ATTACHMENT: RESPONSES TO COMMENTS ON THE DRAFT EIR

FINAL ENVIRONMENTAL IMPACT REPORT FOR THE GWIN ESTATES SUBDIVISION

CITY FILE NO: ER 87-63
CITY REF. NO: PUD 89-270
SCH NO: 89030704

December 1989

Figure 28

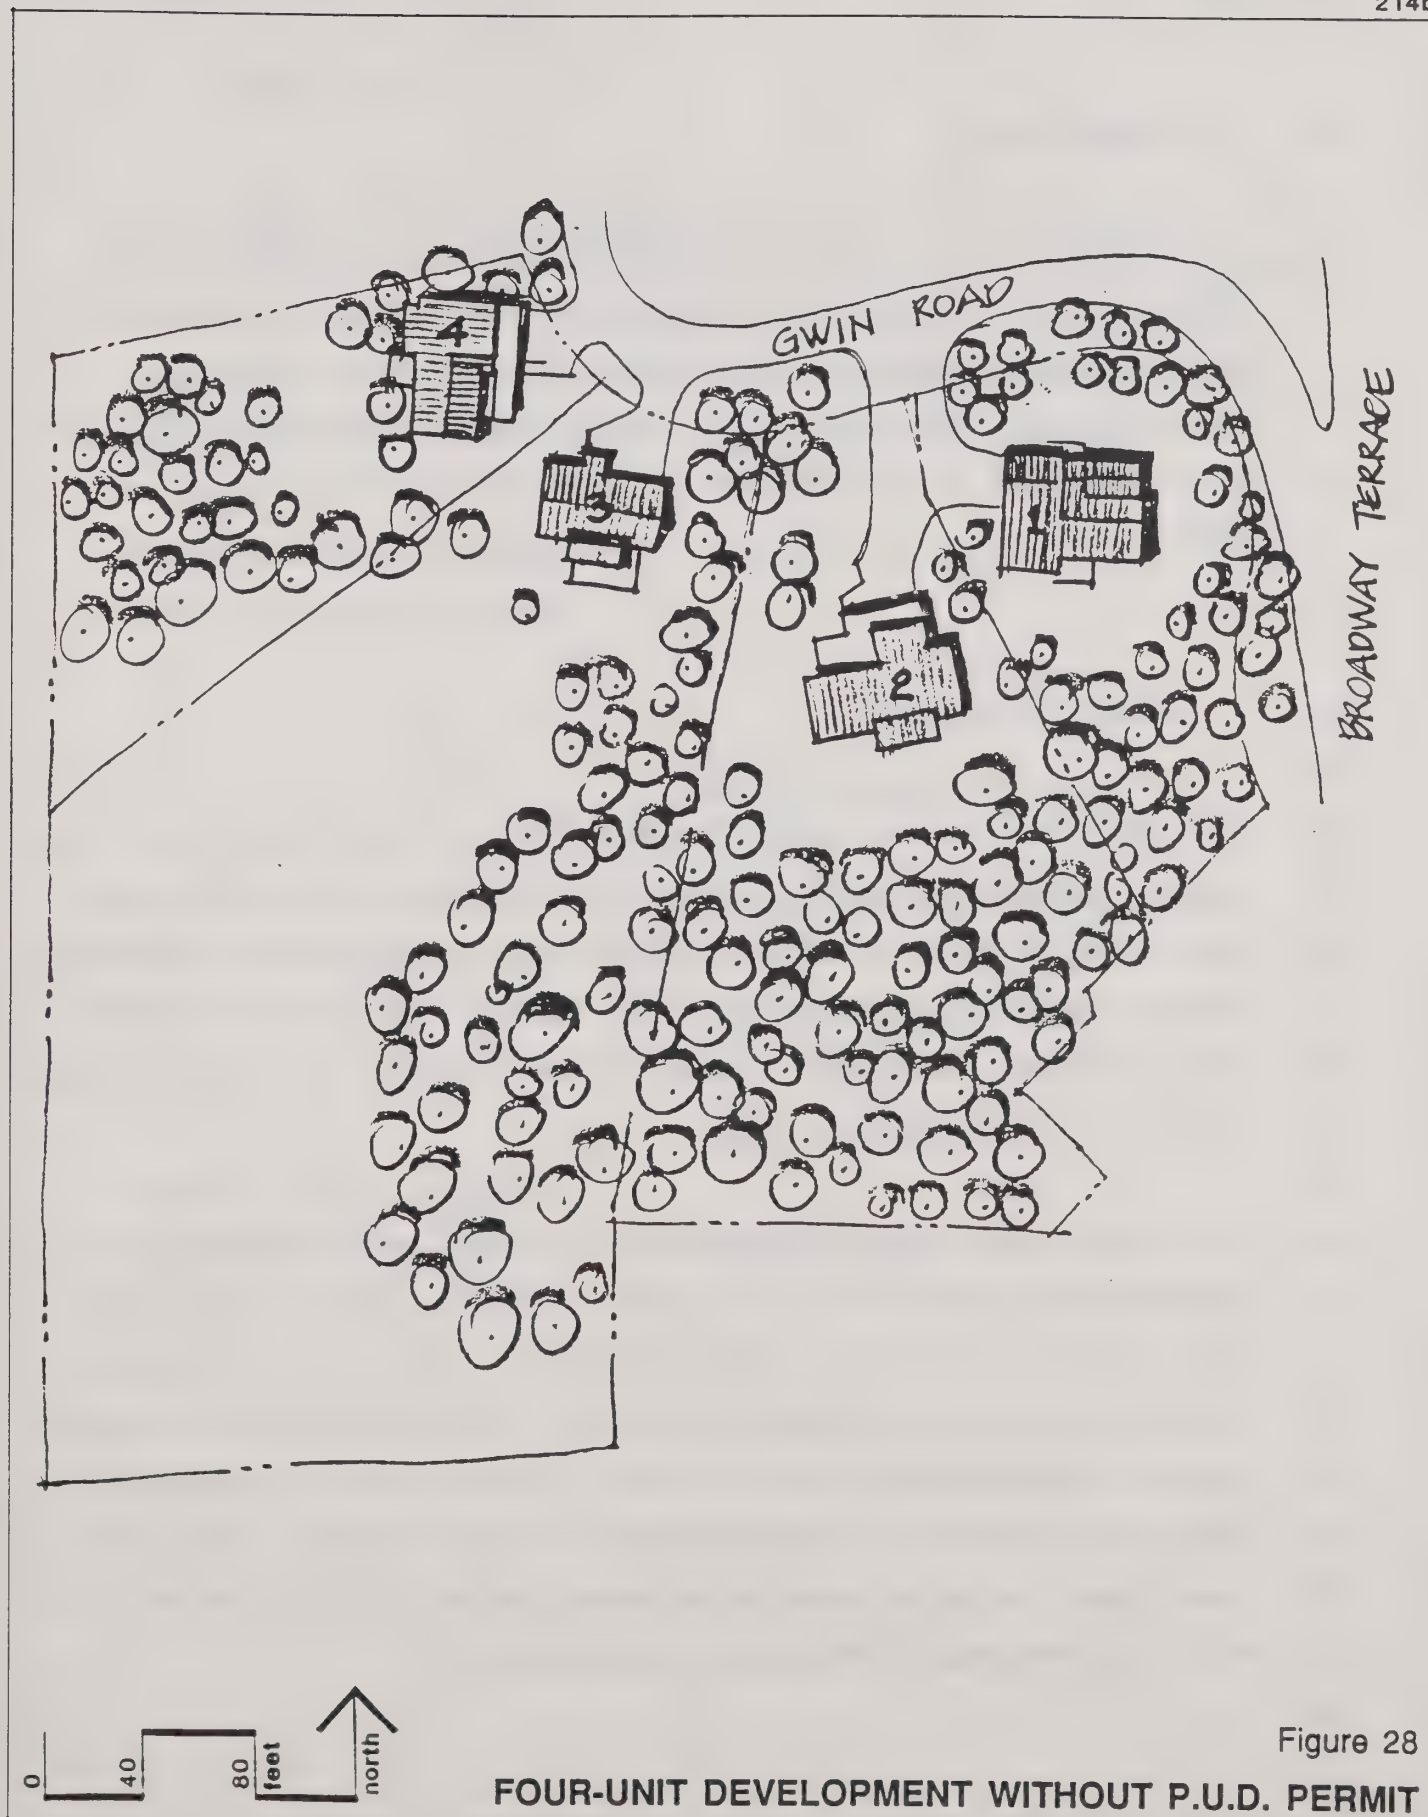
The 4-house Alternative would be more in keeping with Policy Plan, 55637, which specifically focuses on the Forest Park area. "In all development and construction in the Hills (those areas located generally along and northeast of Mt. Blvd) special effort should be made to conserve open space and natural resources. Every development which occurs here on a site of substantial size should reserve the most appropriate portions as permanent open space, and these should generally add up to a significant proportion of the site."

14
15 r Under this alternative, the development program would be reduced to four lots fronting
16 r directly on Gwin Road. The project would be reduced to a minor subdivision, involving
17 r home construction only. No road construction would be involved. Figure 28 depicts this
18 r alternative.
